CNRO-2007-00010

**SUBJECT:** Request for Alternative ANO1-R&R-010  
Proposed Alternative to ASME Code Requirements for Weld Overlay  
Repairs

Arkansas Nuclear One, Unit 1  
Docket No. 50-313  
License No. DPR-51

**REQUEST FOR ADDITIONAL INFORMATION RELATED TO  
REQUEST FOR ALTERNATIVE  
ANO1-R&R-010**

**FIGURE 2**

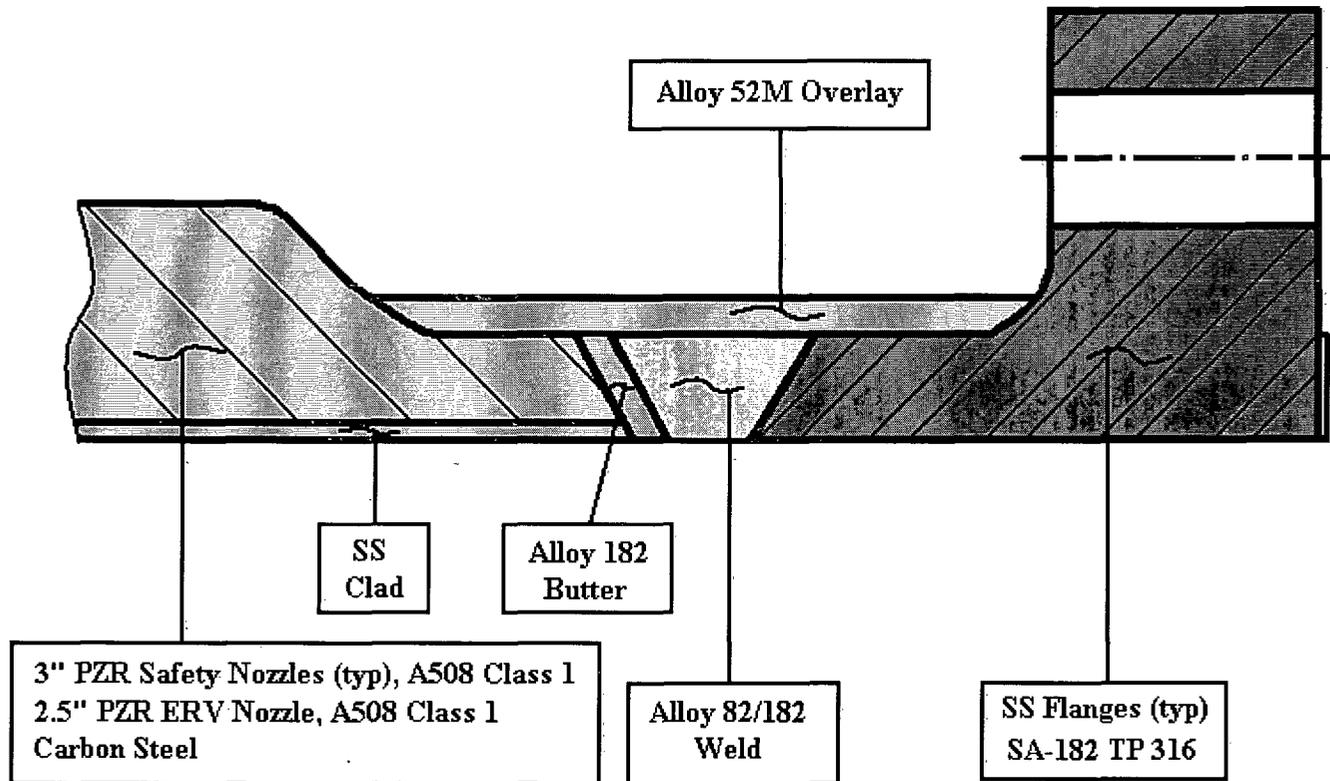
2. On page 3, the licensee stated that the weld overlay will be applied to the dissimilar metal welds between the pressurizer nozzles to the flanges. The staff assumes that these are the flanges of the relief valve and two safety valves. As shown in Figure 2 on page 18, the distance between the pressurizer nozzle and the valve flange seems to be short. Also, the weld overlay will be applied to the valve flange body. Discuss whether the weld shrinkage from the weld overlay on the flange would cause distortion resulting in leakage of the valve flange or exert unanalyzed forces on the flange bolting. Discuss whether the valve will be removed from the flange prior to the weld overlay installation to reduce the impact of weld shrinkage on the flange bolting.

*The subject weld overlays will be applied over the DMWs joining the pressurizer carbon steel nozzles to the stainless steel welding neck flanges as shown in Attachment 1, Figure 2 of Request ANO1-R&R-010. The pressurizer safety relief valves (SRVs) and electromatic relief valve (ERV) are mechanically connected (bolted) to these welding neck flanges. However, during the welding operation, these valves will be unbolted and removed from the system. Therefore, the welding operation will not affect the seating surfaces of the valves or mating surfaces of the flanges. This action will also prevent unanalyzed forces from being applied to the flange bolting.*

*Weld shrinkage due to the weld overlay operation should not result in misalignment or leakage. The expected axial and radial shrinkage due to welding should be symmetric in nature since the overlay regions of the nozzles/flanges are also symmetric. Because the nozzles and flanges are relatively thick members in relation to the thickness and length of the deposited weld overlays, the weld overlays should not substantially distort the welding neck flanges.*
